1966 Corvette: Product Data Book: Radiator Grille Supports

Subject: Radiator Grille Supports

Model and Year: 1966 Corvette

Source: Technical Service Department - Product Data Book

FIGURE 1

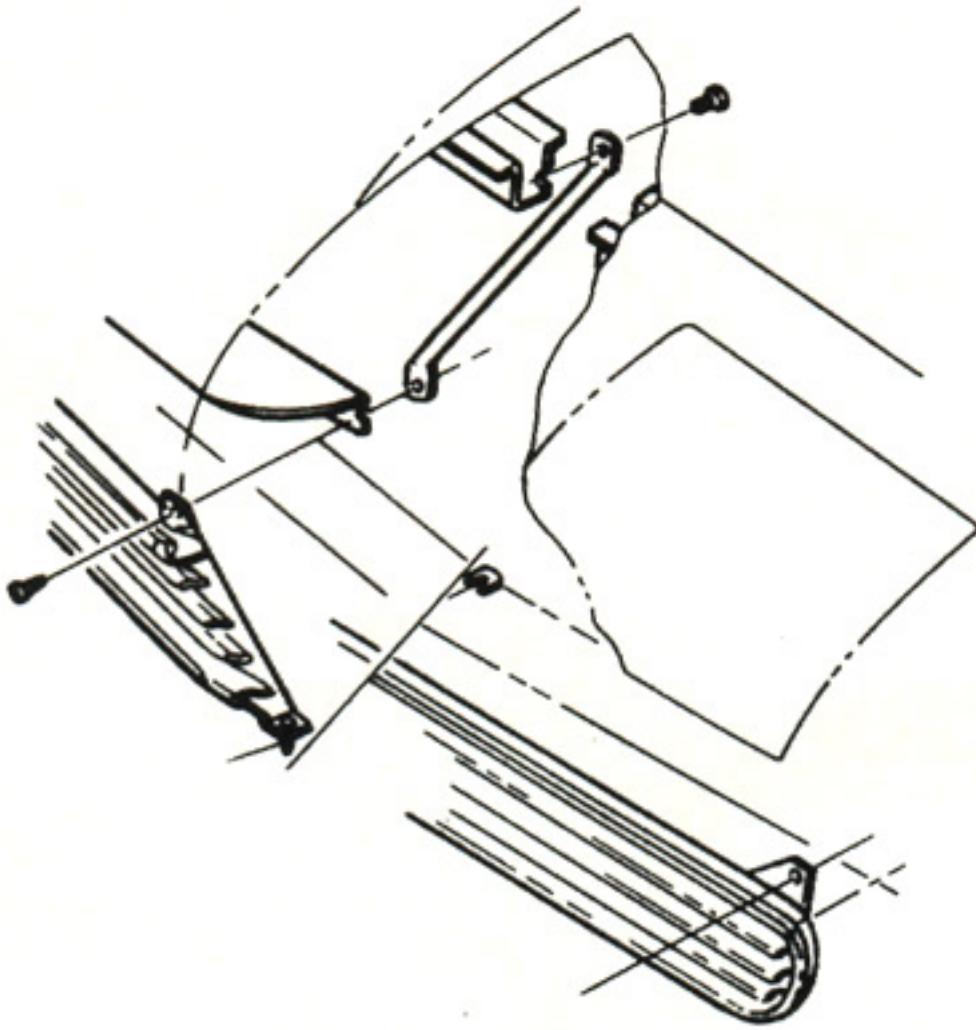
When 1966 Corvettes are driven on rough surface roads, there is a possibility the outer grille supports may break at the body attaching locations.

In production, starting with serial #S115499, the radiator grille supports are of an improved design and a radiator support rod has been added at the center. This is similar to 1965 production.

If outer grille support breakage is encountered on vehicles built prior to serial #S115499, install radiator grille supports, Part No. 3897389, and center radiator support rod, Part No. 3897387. (fig. 1).
